Re: Turkey Point Units 3 and 4
Docket No. 50-250 and 50-251
Response To Request For Additional Information Regarding Overall Integrated
Plan In Response To Order EA-12-051 "Reliable Spent Fuel Pool
Instrumentation"

**RESPONSE TO REQUEST FOR ADDITIONAL INFORMATION
OVERALL INTEGRATED PLAN
IN RESPONSE TO ORDER EA-12-051,
“RELIABLE SPENT FUEL POOL INSTRUMENTATION”**

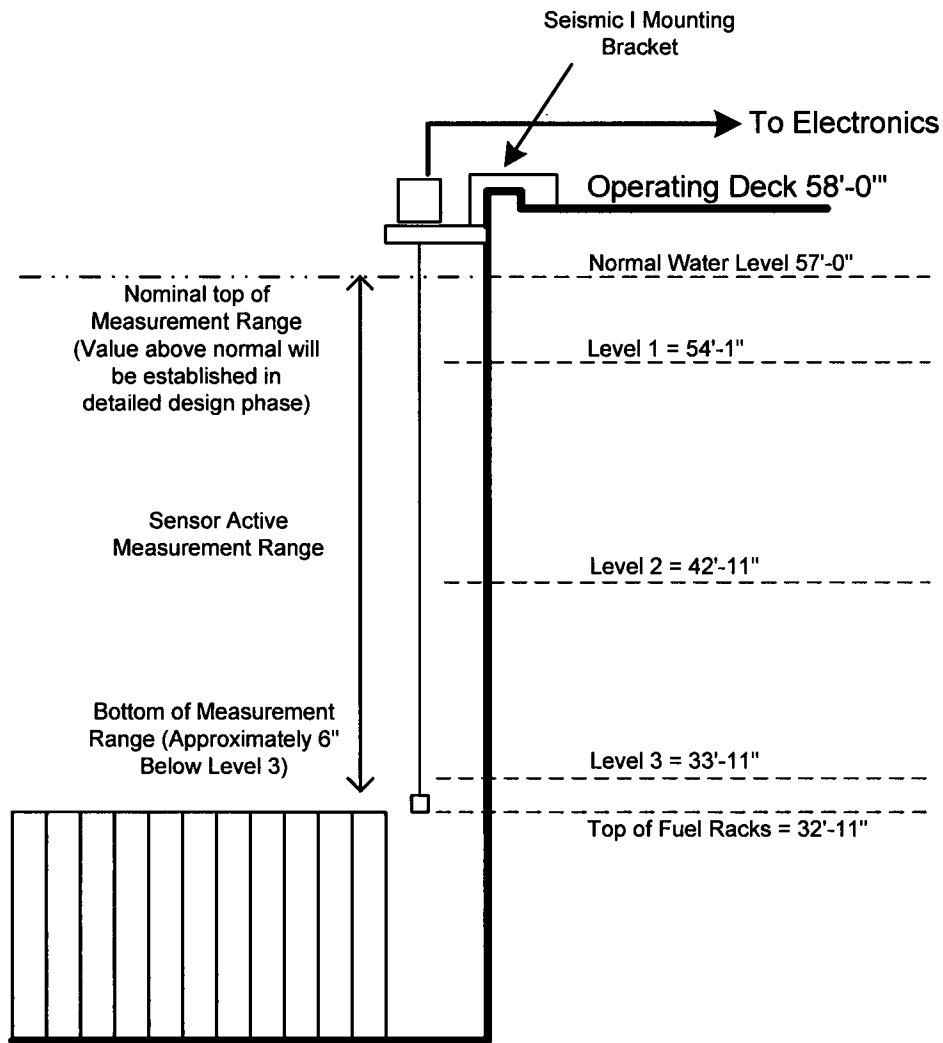
- a. For level 1, specify how the identified elevation represents the HIGHER of the two points described in the NEI 12-02 guidance for this level.
- b. A clearly labeled sketch depicting the elevation view of the proposed typical mounting arrangement for the portions of instrument channel consisting of permanent measurement channel equipment (e.g., fixed level sensors and/or stilling wells, and mounting brackets). Indicate on this sketch the datum values representing Level 1, Level 2, and Level 3 as well as the top of the fuel racks. Indicate on this sketch the portion of the level sensor measurement range that is sensitive to measurement of the fuel pool level, with respect to the Level 1, Level 2, and Level 3 datum points.

The following sketch contains the information requested in RAI-1.b. Instrument uncertainty, which is yet to be determined, is not included in the elevation values for Levels 1 and 3.

Note that FPL is modifying the previously provided elevation previously provided in the OIP for Level 3 based on subsequent industry and regulatory discussions that have occurred since submittal of the OIP.

Accordingly, the previous Level 3 elevation of 32'-11" for PTN (both Units) is being revised to 33'-11".
